PROPOSED BUILDING AMENDMENTS

Project Name
**Gorton
Centrepont**

Drawing Title
**Proposed First Floor Plan
(Comparative Overlay)**

Drawing Number
GCP-KMA-XX-XX-DR-A-7008

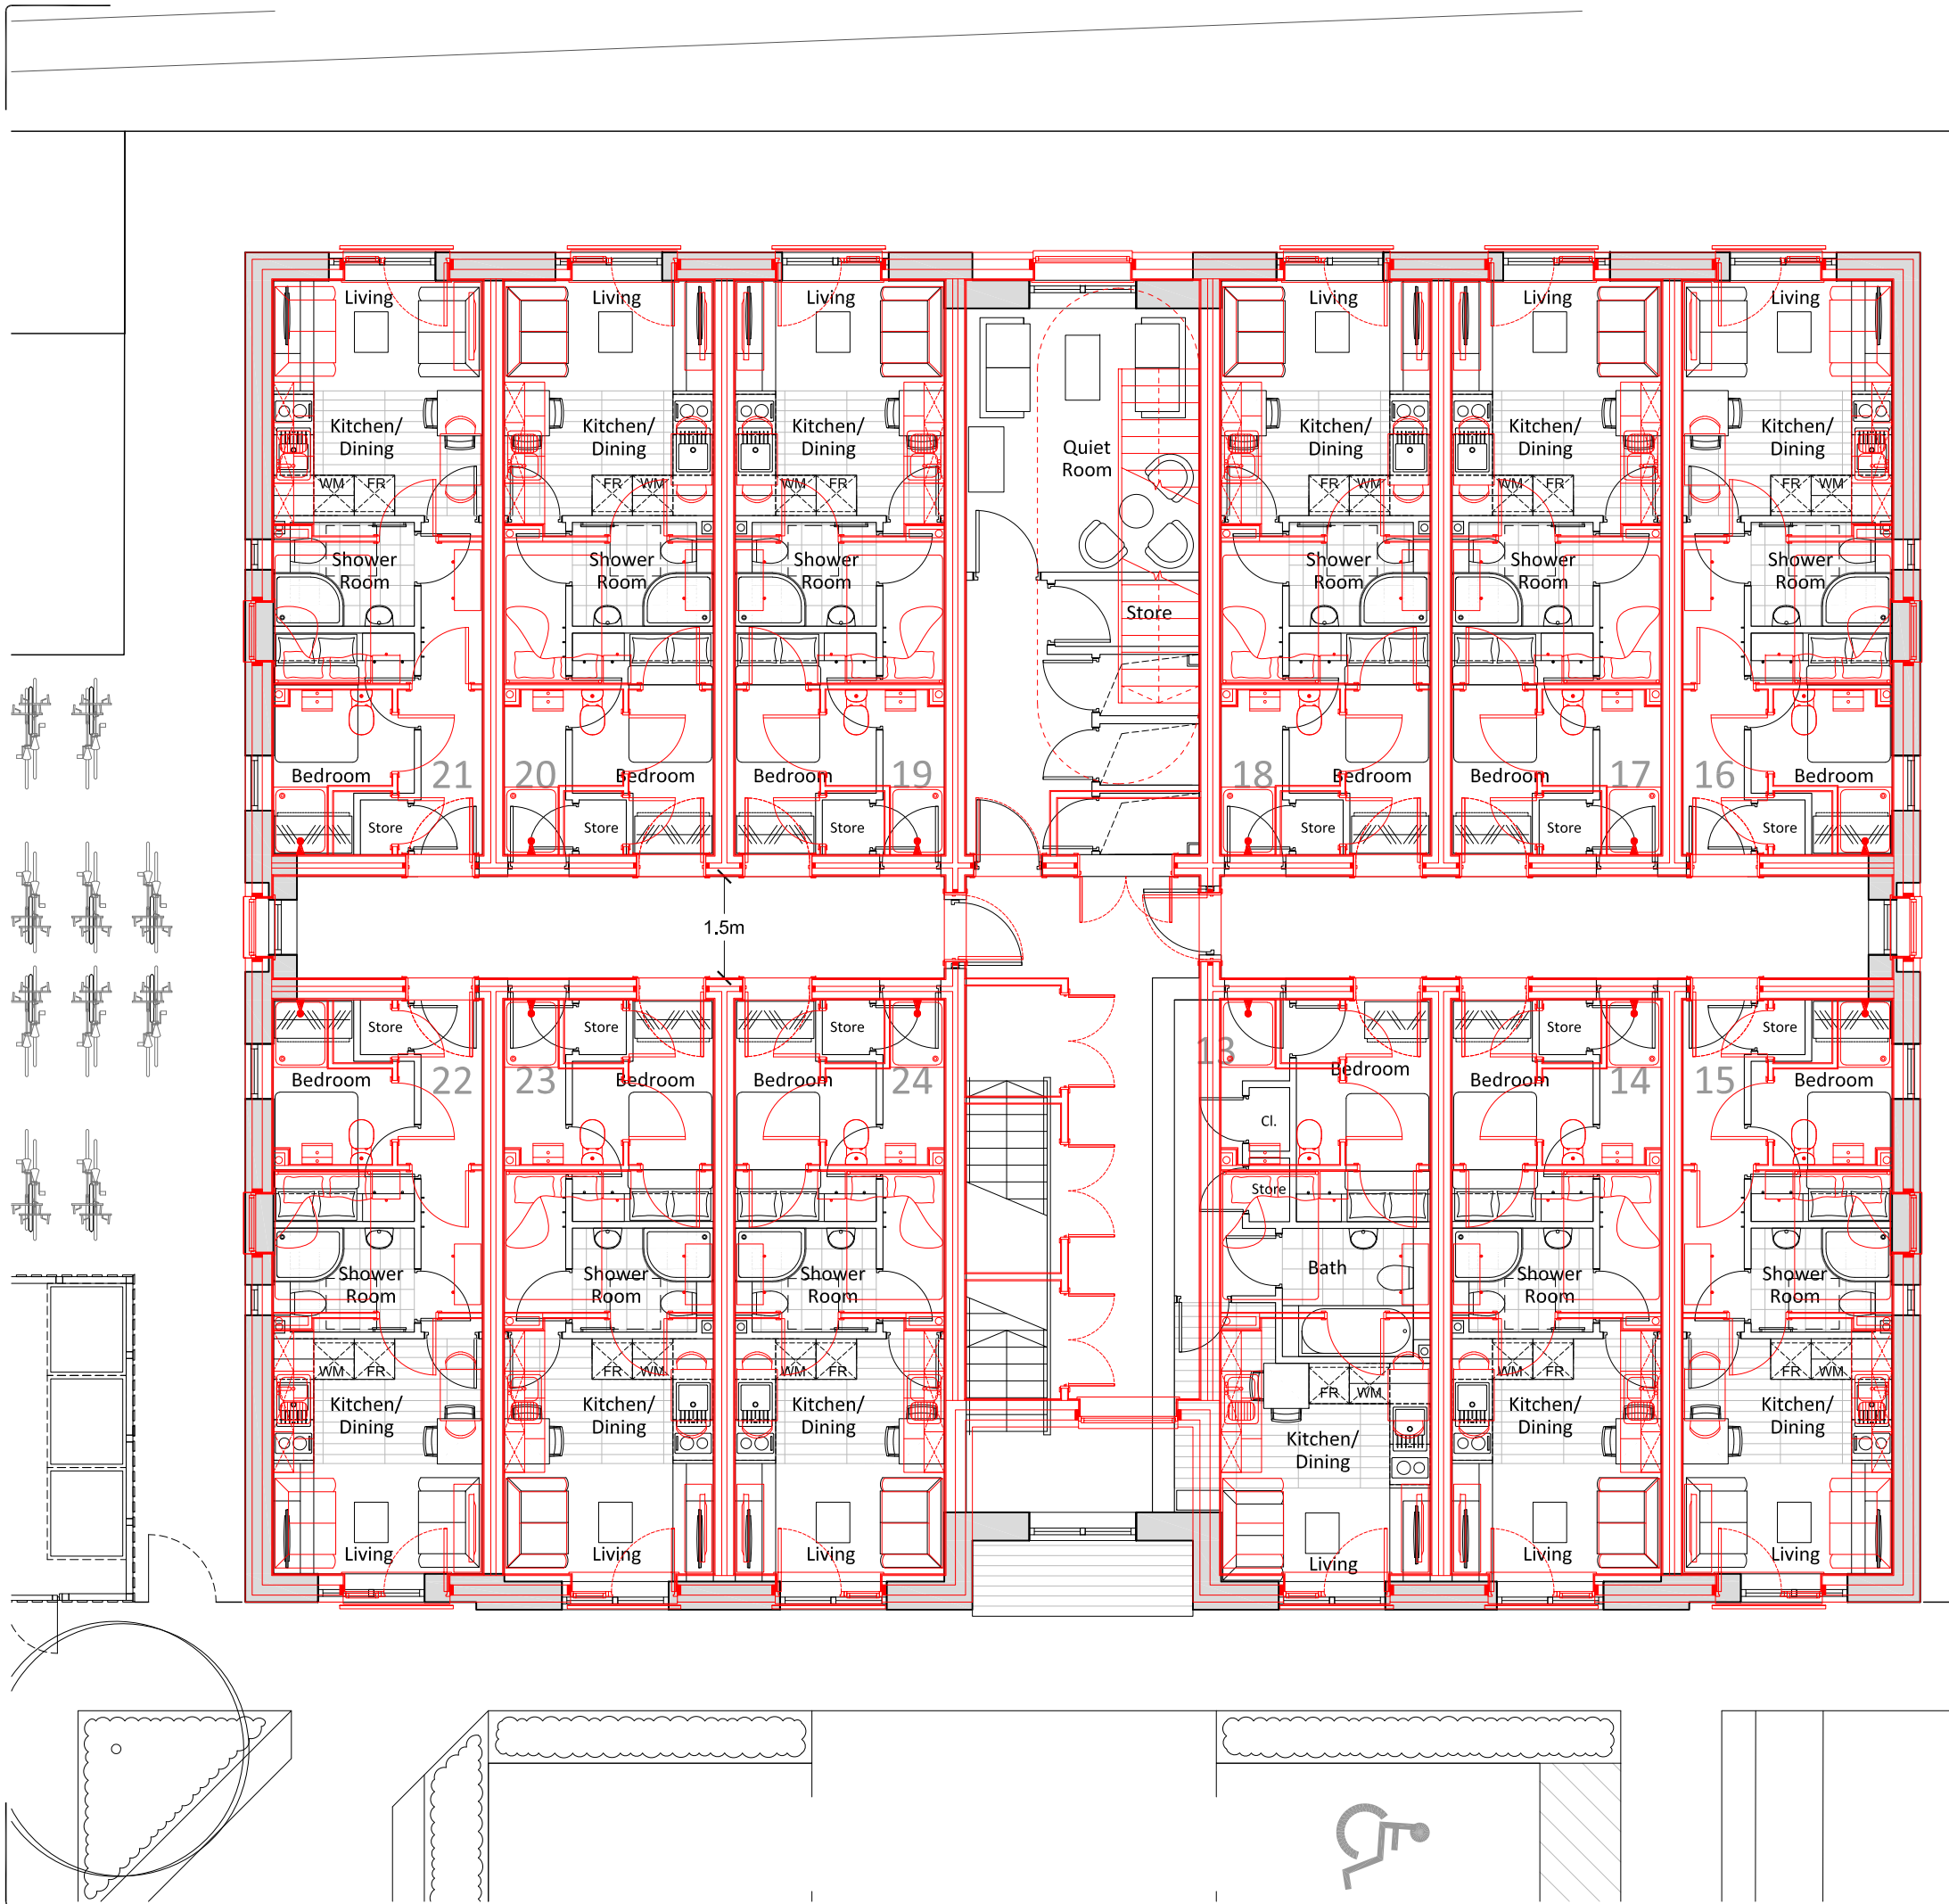
- 2no. (minimal) feature gable projections to be added to the principal elevation.
- The approved flat roof and parapet detail have been replaced with a traditional pitched roof. The proposed ridge height is to remain the same as the approved parapet, but the proposed (lower) eaves height shall reduce the overall visual mass of the building.

- A concealed plant area (securely accessed via the main stair) is located upon the proposed central flat roof section, to be hidden from view by the pitched roof returning front-to-back to form a visual barrier.

- The main entrance is to be pulled forward, but not beyond the approved building line/principal elevation.
- The main entrance is to include for a proposed canopy.

- All solar assisted heating panels are to be removed from the front and rear elevations.
- A PV array is now proposed to the south-facing roof to assist with energy generation.

- All Juliet balconies and associated doors to each apartment are to be replaced with larger openable windows on the front and rear elevations.
- Wall recesses and full-height glazing are to be added to the corridors within each gable end.

- Additional small windows are proposed within each gable end, with no overlooking issues to either the west or east.
- The proposed material palette is to match the adjacent GMYF building in terms of the proposed red facing bricks, artificial slate roof and glazing.
